PROPOSED TECHNICAL SPECIFICATION

ENTERGY OPERATIONS, INC.

ARKANSAS NUCLEAR ONE, UNIT ONE

Subject: Arkansas Nuclear One - Unit 1
Docket No. 50-313
License No. DPR-51
Proposed Technical Specification Change Revising The Pressurizer Code Safety
As-Found Setpoint Tolerance

Figure 1 of
1CAN049606

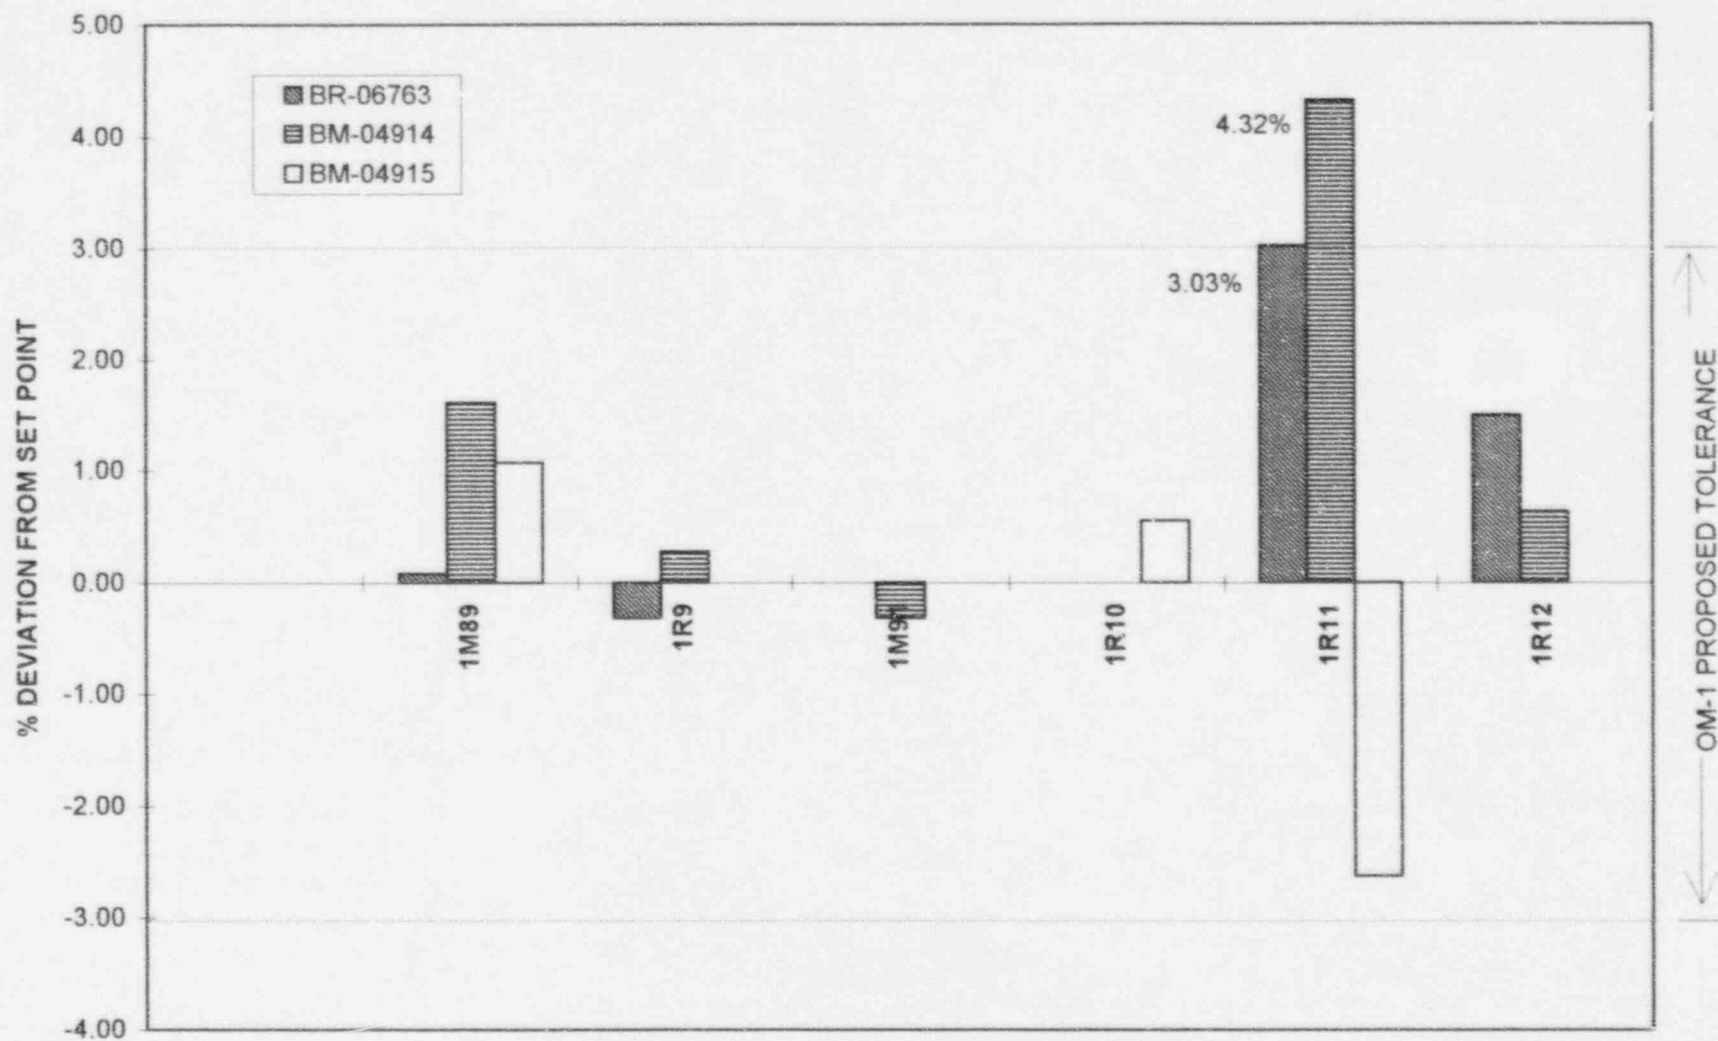
Testing results since 1M89 are summarized in Figure #1 attached to this submittal) for all three ANO-1 pressurizer code safety valves (two valves are in service and one is a spare).

As shown in Figure #1, two of the twelve tests conducted since 1M89 were not within the proposed setpoint tolerance of $\pm 3\%$. The high setpoints both occurred during 1R11 and were attributed to the practice of "jack and lap" after setpoint testing. This process allowed the valve to be partially disassembled, leaving the spring intact, in order to lap the seats to eliminate post testing leakage. After the process was completed, the valve was re-assembled without further setpoint testing. Based on recent information, this repair method can not be used on the Dresser valves without re-verifying the setpoint because the valves utilize four spiral wound gaskets between the body to bonnet interface. Since the gaskets may not compress to the same degree after re-assembly, the spring compression could change thus affecting the setpoint. After both valves lifted out of tolerance during 1R11, the spare valve which had been in storage since 1R10 was tested, and also lifted out-of-tolerance. Since this valve had also been "jack and lapped" without re-verifying the setpoint in 1R10, the practice of "jack and lap" without subsequent setpoint verification was determined to be questionable. Now, if a valve is "jack and lapped," its setpoint must be re-verified.

Figure 3.1.3-1

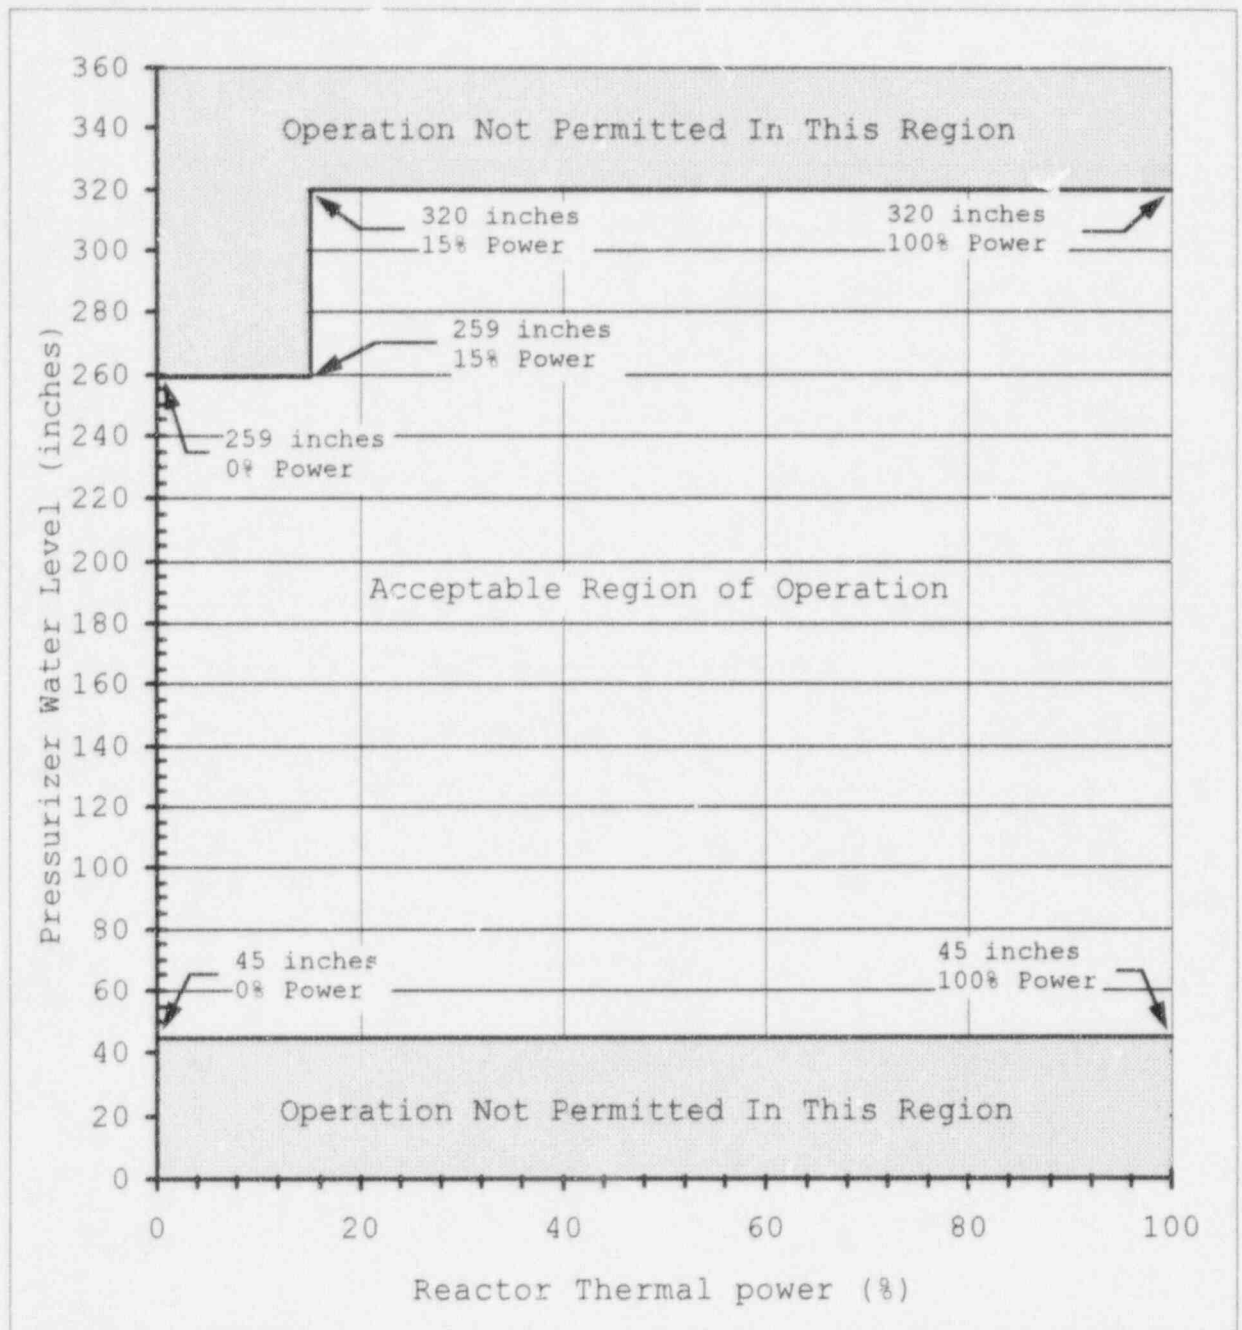
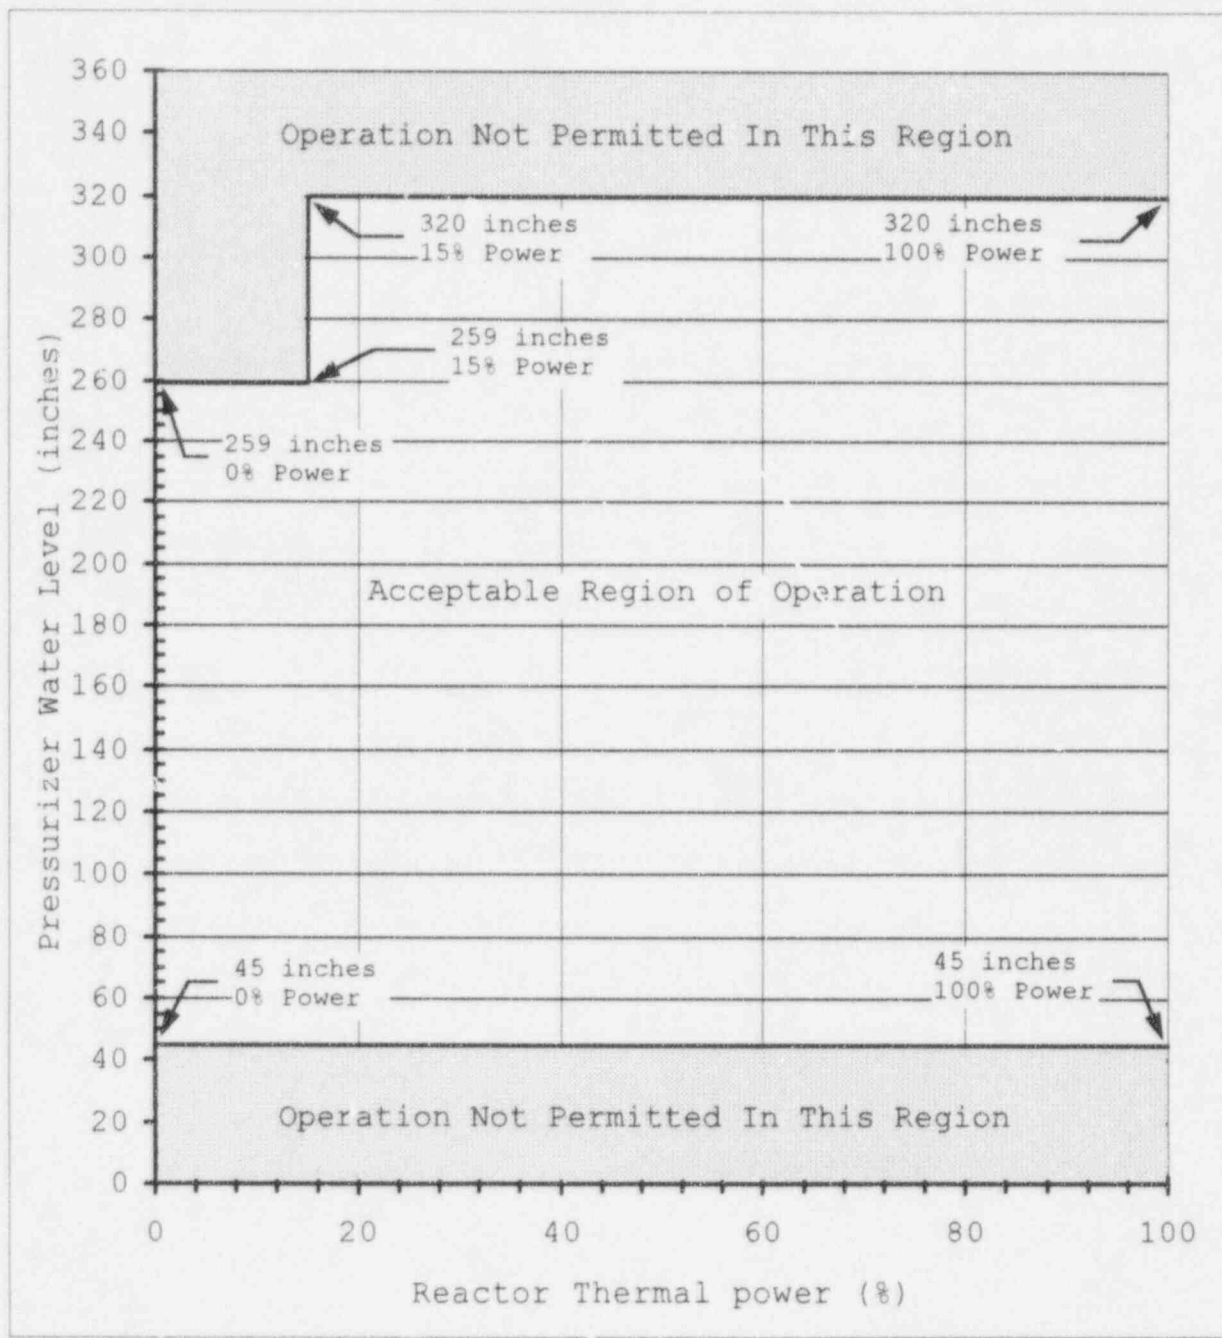
- The pressurizer water level requirements of Specification 3.1.3.4 have been revised to refer to Figure 3.1.3-1, Pressurizer Level Acceptable Range.
- A new page has been inserted to allow incorporation of a new figure. Figure 3.1.3-1 shows the acceptable ranges for pressurizer water level as a function of reactor power, as required by the revised Specification 3.1.3.4.

A new figure, Figure 3.1.3-1, has been added on inserted page 21a specifying the acceptable range for pressurizer level as a function of reactor power. The minimum pressurizer level for all power levels remains at the currently specified 45 inches. From 0% to 15% Rated Power, the pressurizer maximum water level is 259 inches. From 15% to 100% Rated Power, the pressurizer maximum water level is 320 inches.

Figure 3.1.3-1 also contains a note to clarify that the specified pressurizer levels and reactor power levels do not contain an allowance for instrument error. The previous pressurizer level requirements were specified as "indicated" levels. No reference was made in the associated Bases to indicate whether instrument error was included in these limits. Since the values for pressurizer level and reactor power used as inputs to the startup and rod withdrawal analyses were not corrected by the inclusion of instrument error, this note indicates that values used for controls in the plant procedures should be corrected for the instrument error allowance.

- 3.1.3.4 The reactor shall be maintained subcritical by at least 1 percent $\Delta k/k$ until a steam bubble is formed and a pressurizer water level within the limits of Figure 3.1.3-1 is established.
